# TECHNICAL SERVICE BULLETIN

**SF – 090 Rev.3**

DATE: **February 21, 2024**  
TO: All Service and Parts Managers  
SUBJECT: Field modifications required for certain evaporator coil drain pans paired with condensing furnaces in upflow applications

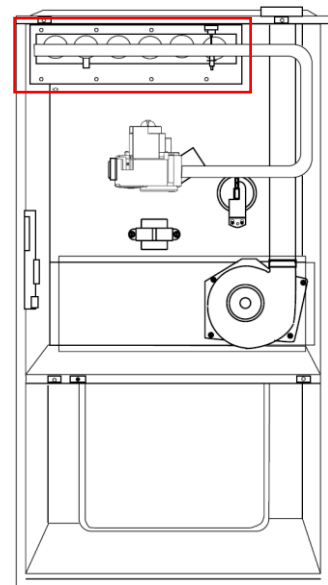
1. Any coil installed in a downflow application.
2. Any coil matched with a non-condensing (80% AFUE) gas furnace (any brand).
  - a. ONLY applies to heat exchanger configurations where burner input is located **at the bottom**. If burner input is located at the top of the heat exchanger (as shown in picture to the right) the furnace is **not exempt** and will require further action.
